**SUBJECT: Temporary Design Bulletin C02-08
Effective April 16, 2002**

This bulletin supersedes Temporary Design Bulletin C02-03.

FDOT NOISE WALL PILE/POST CONNECTION OPTIONS – GENERAL NOTES (Page 1 of 2)

FDOT NOISE WALL PILE/POST CONNECTION - OPTION NO. 3B (Page 1 of 2)

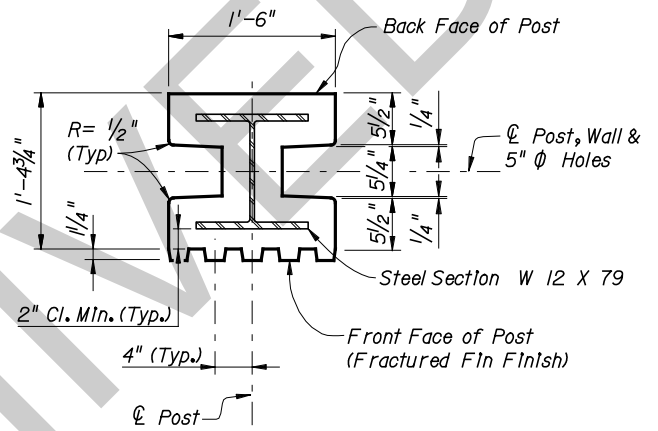
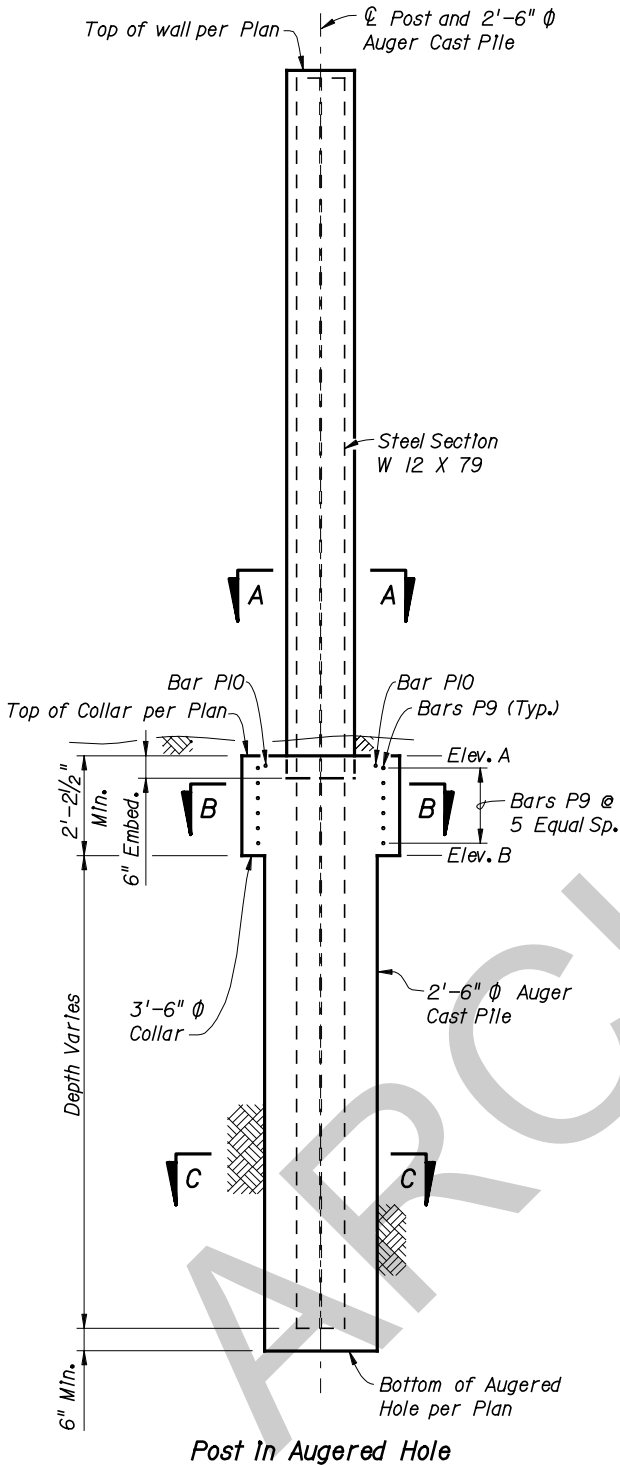
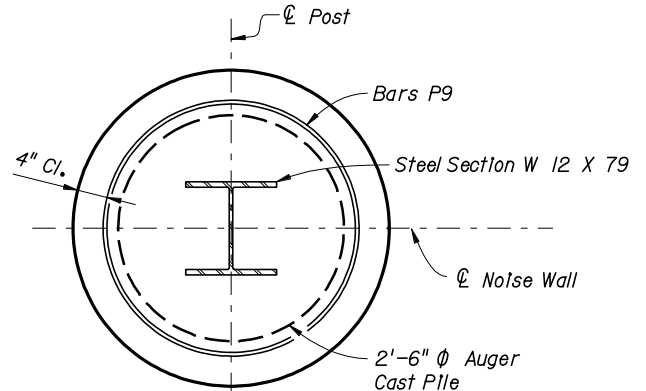
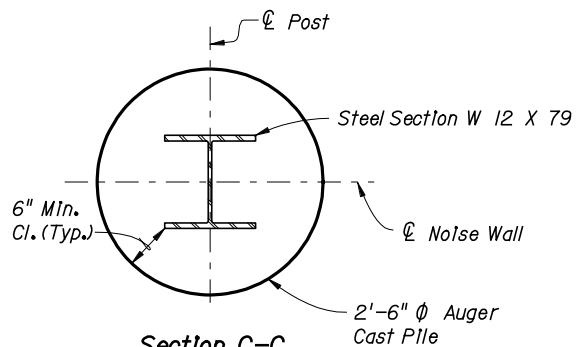
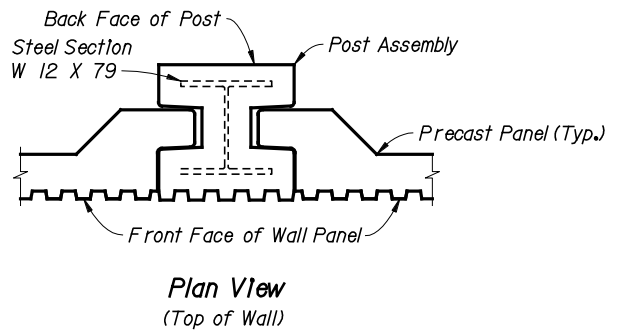
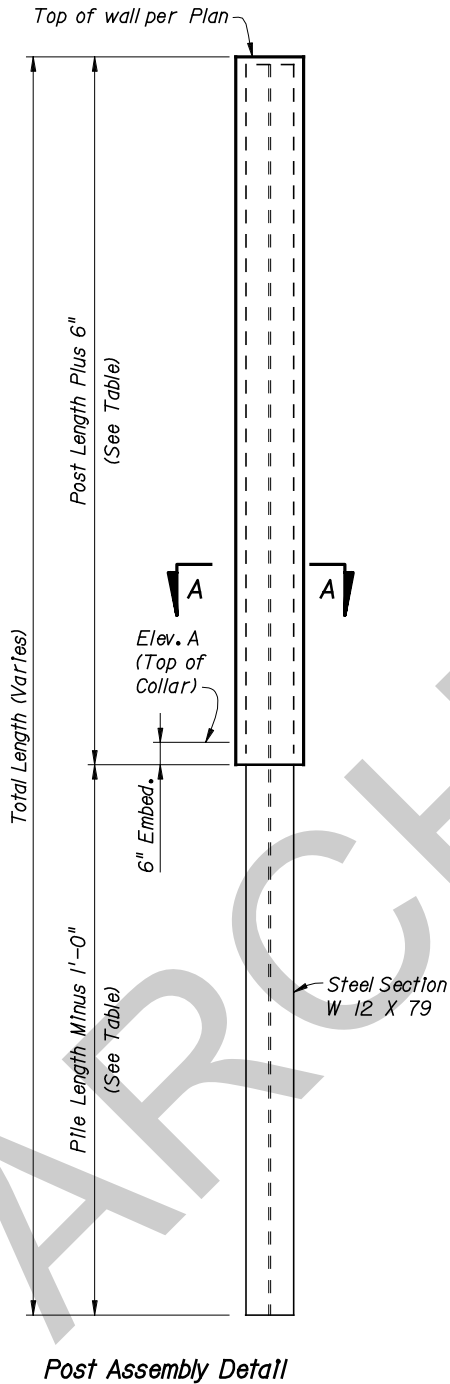
Option 3B

Replaces precast concrete post with structural steel post covered with concrete for durability and aesthetic reasons and to make connections to the panels. Deletes auger cast pile reinforcement. The 5" dia. holes are drilled into the steel post web to facilitate pouring concrete around structural member.

The W 12 X 79 load carrying member is coated with concrete for durability, aesthetic reasons and to make the connection to the panels.

The steel and concrete post assembly is not a reinforced concrete design.

The steel and concrete post assembly shall be cast vertical or cast horizontal according to the casting orientation shown on page 2 of 2.

All Structural Steel shall be in accordance with ASTM A36.
